This submission to the Department of Planning and Environment (Department) comprises a response to comments received from City of Ryde Council (Council) and State Government agencies during the exhibition of the Section 75W Modification Application to amend the Part 3A Concept Plan Approval (MP 09_0209).

This is the second Section 75W Modification Application made in relation to the Part 3A Concept Plan Approval for the 'Macquarie Park Commerce Centre' located at 396 Lane Cove Road and 2 Coolinga Street, Macquarie Park (the site). The exhibited Modification Application amends the approved concept for the site to reflect the culmination of some five years of market testing, design development, and aspiration to provide the best possible outcome for the site and deliver a landmark development at an important gateway within the Macquarie Park Corridor.

A Section 75W Modification Application (S75W) for the Part 3A Concept Approval for the Macquarie Park Commerce Centre at 396 Lane Cove Road & 2 Coolinga Street, Macquarie Park (MP 09_0209), was notified for a period of 2 weeks between 28 February 2018 and 14 March 2018.

Figure 1 Pedestrian links that were analysed to understand capacity and level of service

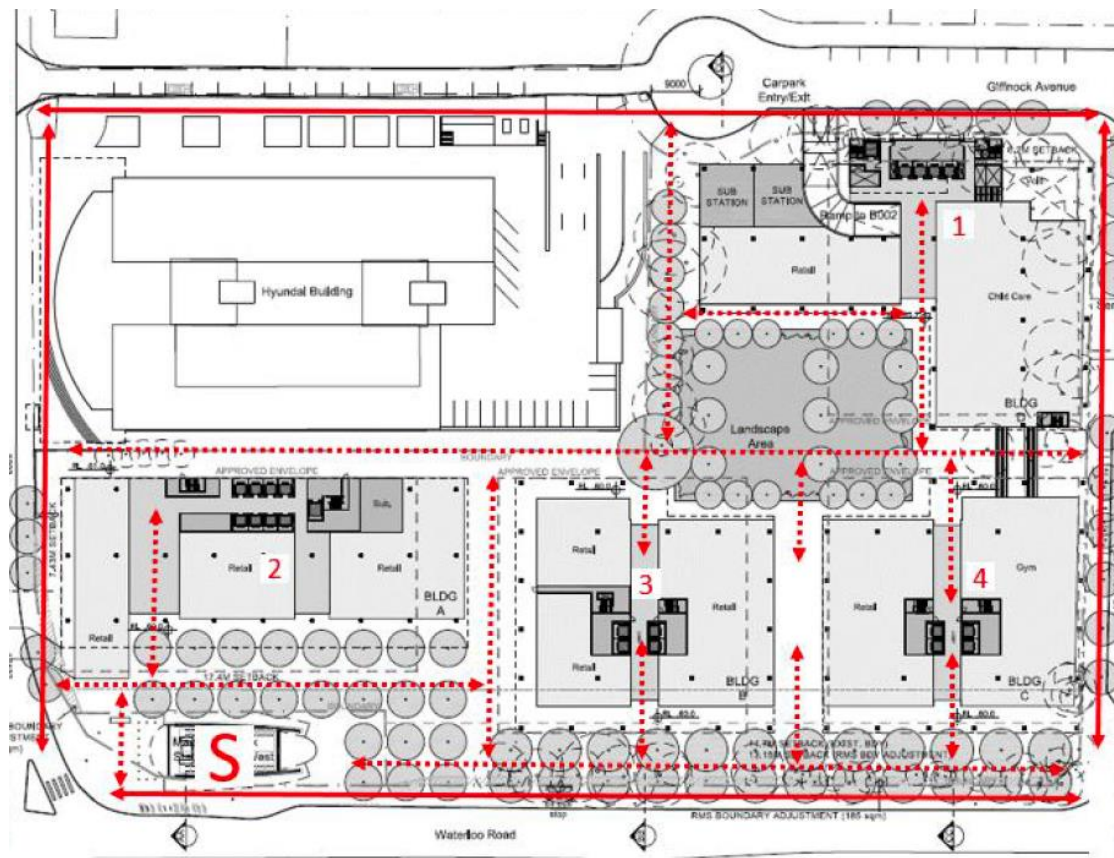
- *Provide further consideration of the adequacy of the proposed laneway widths to accommodate pedestrian movements, as well as areas for seating, landscaping and other elements*
- *Clarify the location of existing views and provide additional views through the laneways, particularly between Buildings A and B, comparing the approved and proposed scheme.*

- *The usability and capacity of the laneway would be compromised by the reduced width from 15m down to 9m given that these laneways would also be occupied by table and chairs for outdoor eating/ recreation, planting, planter boxes and awnings as shown on the landscape plan and in the planning report.*

In order to demonstrate the capacity of the modified laneways to accommodate pedestrian movements, the S75W was accompanied by a pedestrian capacity analysis prepared by WSP (Appendix D of the S75W Report). This analysis assessed the pedestrian connections and pathways within the site (see **Figure 1** below) to determine the level of service that would be provided, being an analysis of the number of pedestrians per metre of clear footway width and per minute based on an analysis of pedestrian activity and the street environment. It measures the width of the pedestrian link at its narrowest point, to understand the usable width that is available for pedestrian movement and discounts the components of the footway that cannot be used for movement including street furniture, trees, the kerb edge, and shop facades and their associated buffers. The updated report at **Appendix C** now makes specific reference to the architectural sections of the proposed laneways, to avoid any uncertainty. The results discussed below demonstrate that the proposed laneways are more than capable of accommodating pedestrian movements and will not result in compromised through-block connections.

The analysis considers 35 locations across the site and determines the pedestrian volumes and associated Level of Service (LOS) that can be expected at each location, taking into consideration the growth of pedestrian movements over the next decade. The analysis confirms that during peak AM and PM periods, all pedestrian thoroughfares on the site will achieve a level of LOS A, with the exception of the pedestrian path on the northern side of Building D fronting the internal open space area that will achieve LOS B owing to the pathway width and the use of outdoor seating in this area. These pedestrian pathways were targeted to achieve LOS B or D, and as such the proposed development has achieved or exceeded the criteria in every scenario and at every location.

WSP confirms that on the grounds of pedestrian capacity; “all footway connections were shown to comply with the target Level of Service B, with almost all links performing at Level of Service A. This demonstrates a good provision of pedestrian space.” The proposed laneways are therefore more than adequate to accommodate pedestrian movements.

Figure 15 Approved (top) and proposed (bottom) through-site circulation shown in the red dotted line

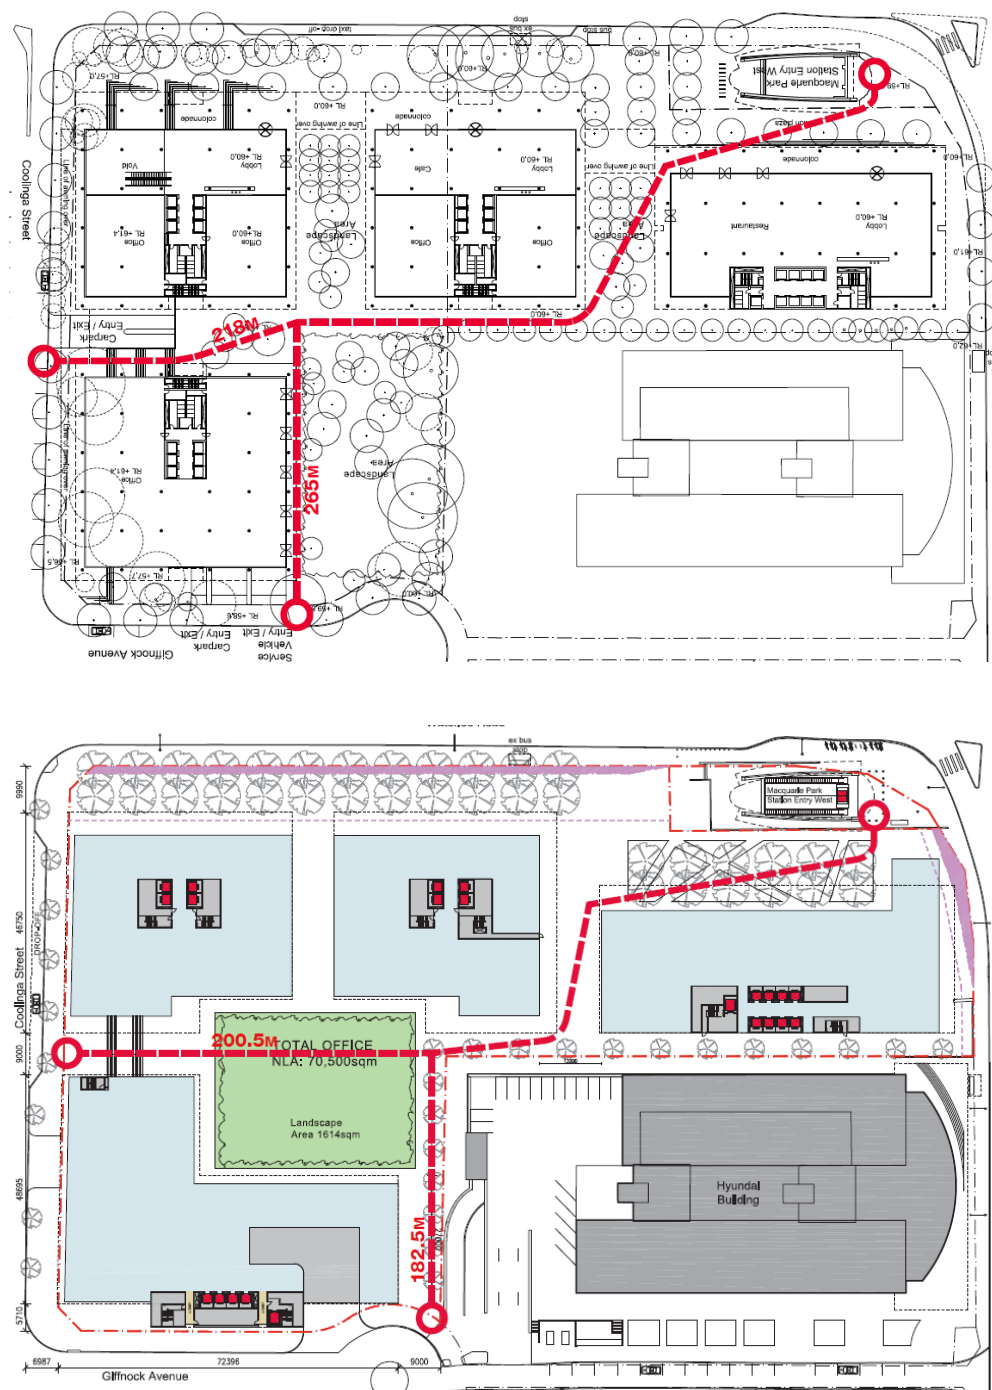
- *The physical connectivity and site through link for pedestrians provided under the existing scheme diminishes significantly between the Lane Cove Road and the internal park because of the narrower laneways.*

The physical connectivity of the amended through-site links, and the resultant ability of pedestrians to move through the site will not be impacted. It is emphasised that the proposed laneways are in the same general locations as approved, and will facilitate the same through-block connections as approved, with the Modification Application resulting in some minor improvements to the distances travelled from the Station Plaza through the site (see **Figure 15** below).

Figure 16 Commercial building separation control

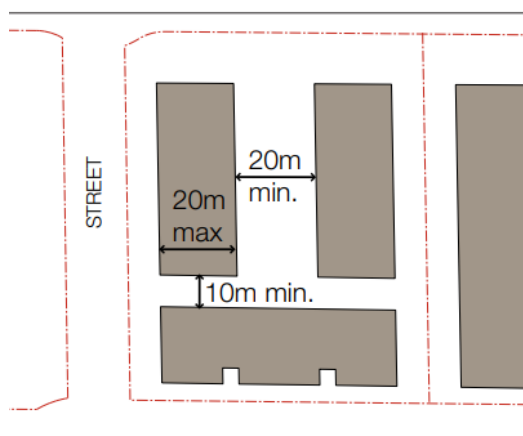
- *The reduced width of the laneways (which also acts as the building separation distance) will also breach the required building separation between building A, B and C as per Councils Development Control Plan 2014 (DCP)- Part 4.5 Figure 4.7.1.*

- *This is also the building separation setbacks required between individual buildings on the site that is critical in providing solar access to buildings and communal areas, allows for visual privacy and outlook between buildings.*

The reduced width of the laneways remains generally consistent with the suggested building separation distances for commercial buildings under Part 4.5, Figure 4.7, of the *Ryde Development Control Plan 2014* (Ryde DCP). This provision suggests that a minimum 10m building separation distance be achieved between buildings that are perpendicular to each other on the same site, and a 20m separation distance between buildings that are facing each other on the same site.

The reconfigured building envelopes achieve a minimum 9m separation distance between perpendicular building facades and a minimum 37m separation distance between the faces of the buildings that overlook each other and the open space area in the centre of the site. The development is therefore generally consistent with the provision and will achieve the objectives of this control in providing visual breaks between buildings, improving the outlook from buildings that now oversee the open space area in the centre of the site, and retaining a similar level of solar access or improving solar access in key open space areas within the site (as demonstrated in **Section 2.2** below).

The proposed separation distances will also have a negligible impact on visual privacy between commercial tenancies, which can be mitigated with façade treatments such as cladding, angled glazing, orientated key congregation/socialising spaces to overlook the park or plaza. The proposed changes are also key to providing greater public benefits on the site in terms of the increased public plaza, increased and more functional open space areas, and improved site activation.

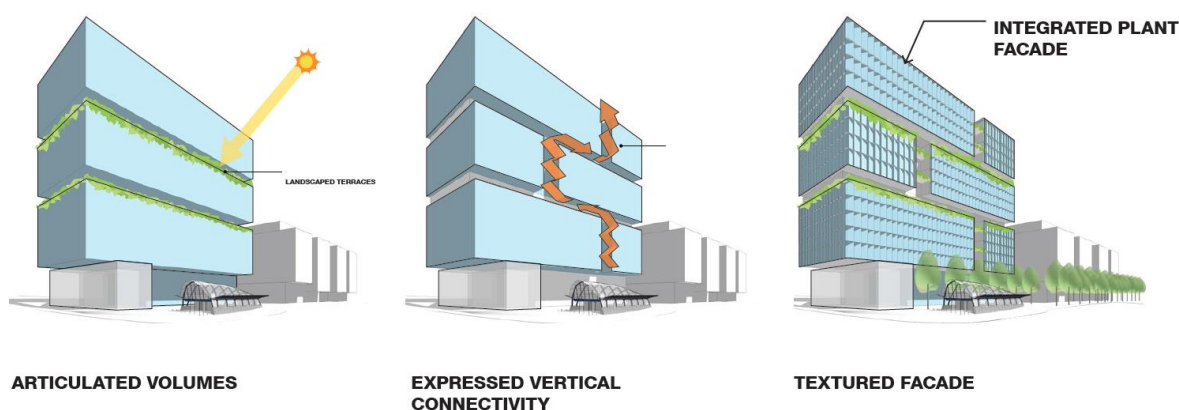
The Department has requested that the proponent review the extent of rooftop plant on Building A, and incorporate setbacks to the north west, north east and south east.

The S75W has revised the zone for rooftop plant for Building A, allocating the complete rooftop area for the provision of plant and building services. This revision results from further design development and testing and is for two reasons, being to deliver the capacity of building services necessary for a functional building and to deliver a resolved architectural form.

The proposed plant level has been designed with consideration of the area of mechanical plant and other base building services that are required to service the base building. Reducing the extent of this plant level could result in an insufficient area to meet the servicing and plant requirements of the building.

Further, the intent is to better integrate plant and building services with the overall built form and massing of the building, to create a more resolved roof form. Development in a prominent corner within the Macquarie Park corridor should avoid isolated and unattractive rooftop plant and services that sit like a 'top-hat' above the roofline. The objective for the future detailed design of the Building A envelope will therefore be to present a consistent roofline that achieves the approved maximum building height.

Consistent with this approach, the supplementary architectural report at **Appendix B** details how the future detailed design of the building envelope can integrate the plant level with the building form and contribute to the architectural integrity of the building. An optimum outcome for the detailed design of the Building A envelope would be to create stacked volumes that emphasise and articulate the building through landscaped external terraces and expressed vertical connectivity through the building. Under this indicative design scenario, the plant level can be fully integrated with the buildings architecture, will assist in balancing the façade articulation, and are disguised and indistinguishable from the remaining building when viewed from afar.

Figure 18 Approved and proposed setback of the building to the Station entry

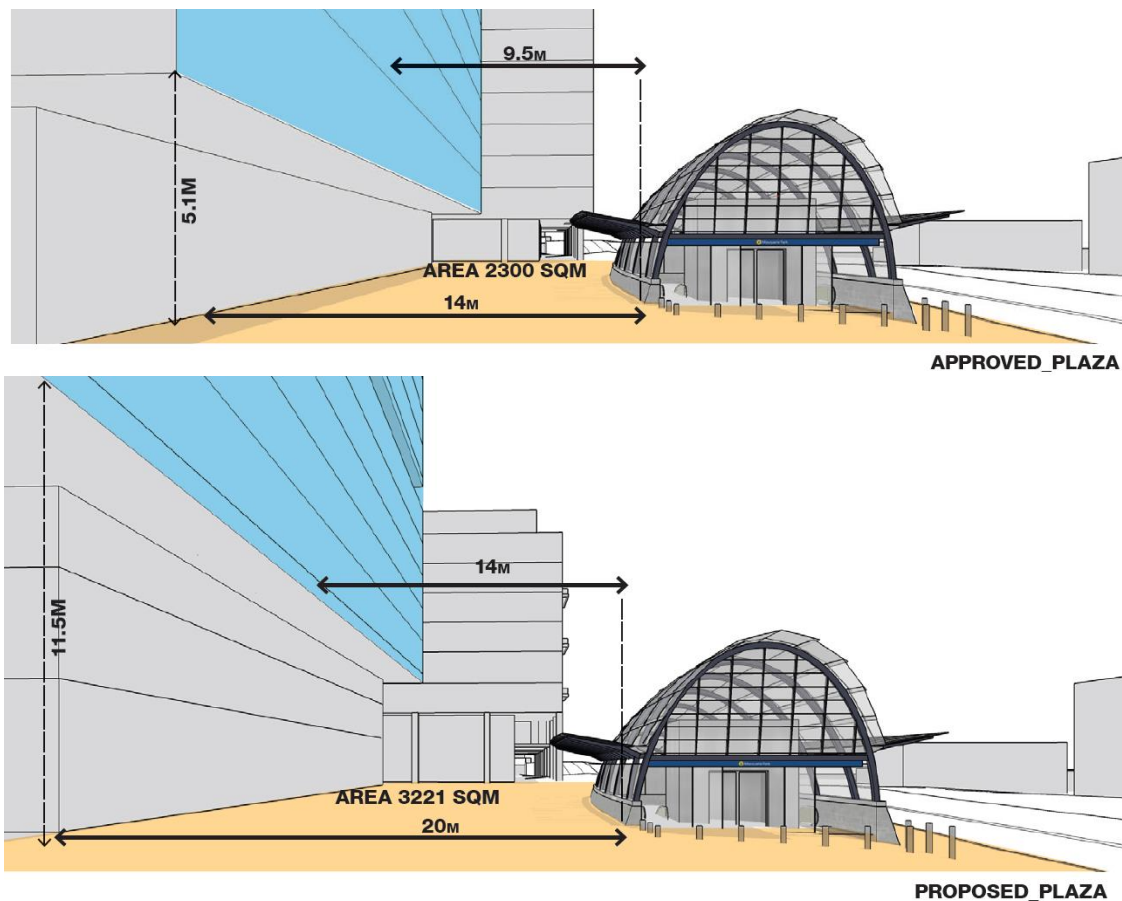
The Department has requested that the ground floor protrusion from the station entry and site boundary be dimensioned, and that an additional view be provided showing the area for pedestrian movement.

The revised envelope plans at **Appendix B** detail the setbacks of the ground floor protrusion and colonnade area on the ground floor of Building A where it interfaces with the entry portal of the Macquarie Park Station. The setback between Building A and the station portal has generally been increased from 14m to 20m at the ground floor (see **Figure 17** and **Figure 18** below). The small 'L-shaped' projection along Lane Cove Road has been amended to sit

Figure 22 Indicative section showing the location of the child care centre and its dedicated outdoor terrace
Source: Bates Smart

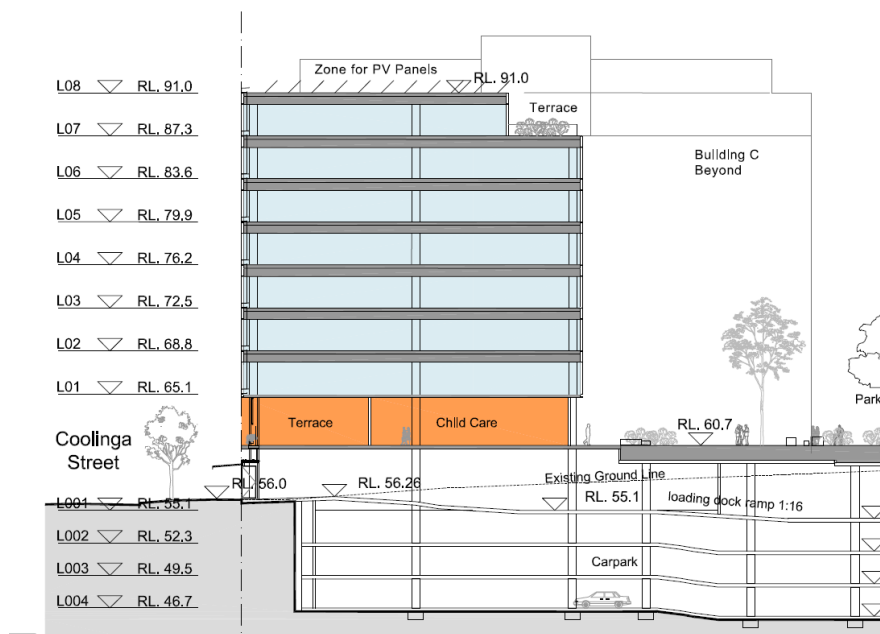
The Department has requested that the proponent demonstrate that a future child care centre on the site will be provided with adequate outdoor play area(s). This is supplemented by Council's comment, which suggests that the lack of a separate outdoor area could result in an encroachment or displacement of the landscaped area in the centre of the site or the plaza.

The current intention for the child care centre is to provide a dedicated outdoor terrace overlooking Coolinga Street that is secure and separate to the landscaped area and Plaza identified in the Modification Application (see **Figure 21** below). This outdoor terrace will not displace any of the public domain areas identified in the Modification Application and will assist in activating the Coolinga Street frontage.

It is emphasised that this is an indicative treatment, and that the detailed design and operation of the centre will be the subject of a separate application pursuant to the CPA. As part of this separate approval process, any child care centre will be required to demonstrate compliance with Part 2, Part 3 and Part 4 of the Child Care Guideline and the National Quality Framework Assessment Checklist to validate that the development is consistent with the requirements of Part 4.3 'Physical Environment of the Education and Care Services National Regulations'.
